FINAL FINDINGS AND DECISION BY THE LANDMARKS COMMISSION RENDERED ON March 20, 2017

**CASE FILE NUMBER: LU 16-153002 HRM AD
PC # 15-247619**

Pearl East Building

Case Type: HRM AD – Historic Resource Review with Modifications and Adjustments

3. TYPICAL WINDOW HEAD (a) AND SILL (b)
1 1/2" = 1'-0"

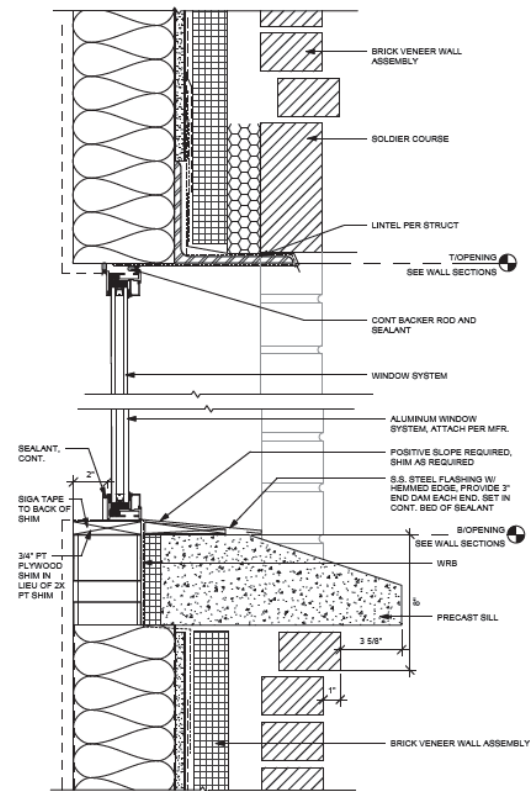
Findings: The two street-facing walls of the building include walls of mostly red brick divided into three horizontal sections divided by two string courses. The middle sections of these wall planes are punctuated by windows which are grouped with a two-tiered inset. The first step in the inset punches back from the building plane 3 5/8" inches. The insets then step back another inch before the beginning of the window (see figure from Exhibit C-15). The middle section includes windows that are grouped in threes like many of the buildings in the district including the historic building directly across 13th Avenue from the site. The ground floor windows are storefront-style windows with transoms which are inspired by but are not exact replicas of the building across the street. The pedestrian zone of the Glisan Street elevation is mostly board-formed concrete resulting in a need to modify the ground floor window standard which is discussed further below. This design is driven by the need to elevate the first floor on 13th Avenue to allow for the elevated loading dock feature on this façade and the desire to maintain the tri-partite design in order to be consistent with the character defining features of many of the buildings in the 13th Avenue Historic District. Project

renderings indicate that the window returns will be brick but this is not detailed in the above window section.

Because the drawing above does not clearly indicate the material of the return staff the Historic Landmarks Commission will require the following condition of approval:

- Window sill returns shall be clad in brick as indicated in the project renderings.
